DEVELOPMENT REVIEW BOARD SUPPLEMENTAL SUBMITTAL

PROJECT NOPR 2021-002017
Application NoSD 2021-00018
TO:
Planning Department/Chair
X Hydrology _X_ Transportation Development _X_ Albuquerque/ Bernalillo Co. WUA Code Enforcement *(Please attach this sheet with each collated set for each board member)
NOTE: ELECTRONIC VERSION (ie disk, thumbdrive) is Required. Submittal will not be accepted without.
DRB SCHEDULED HEARING DATE: HEARING DATE OF DEFERRAL: _JULY 21, 2021_
SUBMITTAL DESCRIPTION:
ABCWUA – FIELD LOCATION OF MANHOLES UPDATED ON SHEET 3; NO ADDITIONAL EASEMENT NEEDED
HYDROLOGY – DRAINAGE FLOW EXHIBIT
TRANSPORTATION – EMAIL FROM FIRE MARSHALL INDICATION NON-ISSUE WITH KEEPING CUL-DE-SAC DIAMETER
CONTACT NAME:DERRICK ARCHULETA
TELEPHONE: 505-980-8365 FMAIL: arch plan@comcast net

LOTS 27 P-1A AND 29 P-1A OXBOW BLUFF SUBDIVISION

RE: OXBOW BLUFF SUBDIVISION

SHEET 3 OF 3

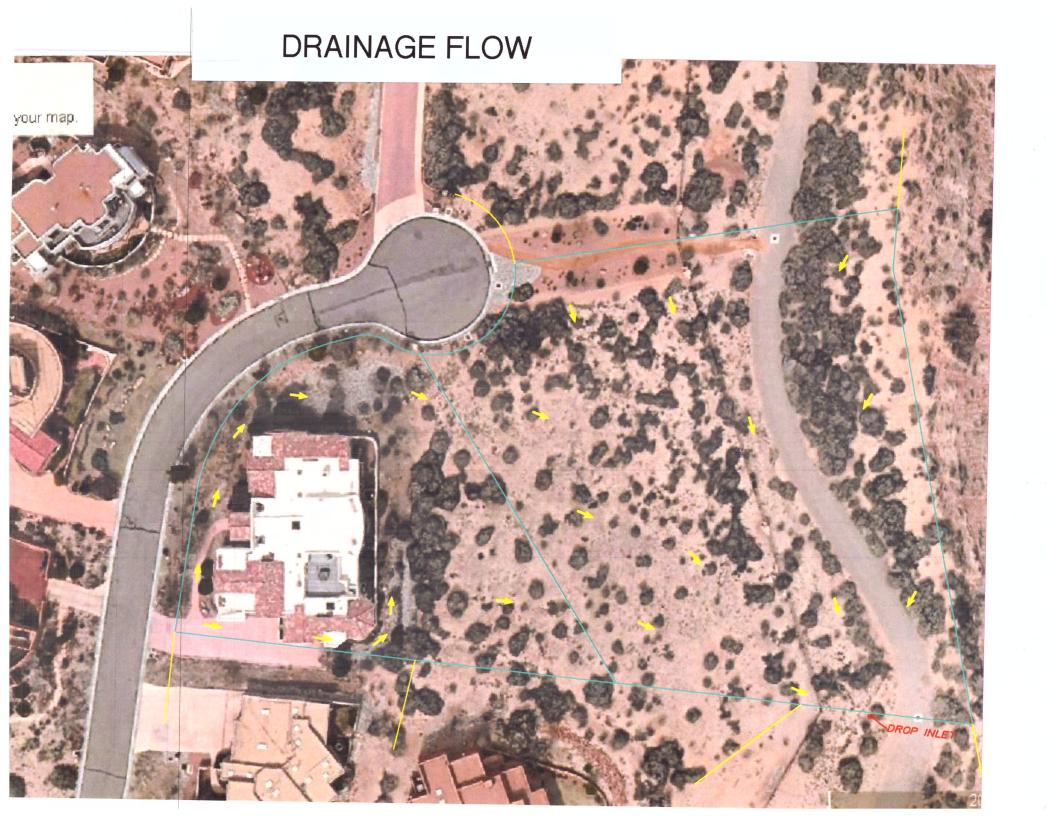
Transportation is asking for Fire Marshall approval for keeping the cul-de-sac at its current diameter.

The plans submitted for Ox Bow Subdivision are approved by the Fire Marshals Office and require no change to said plans. Feel free to contact me if you require any additional assistance.
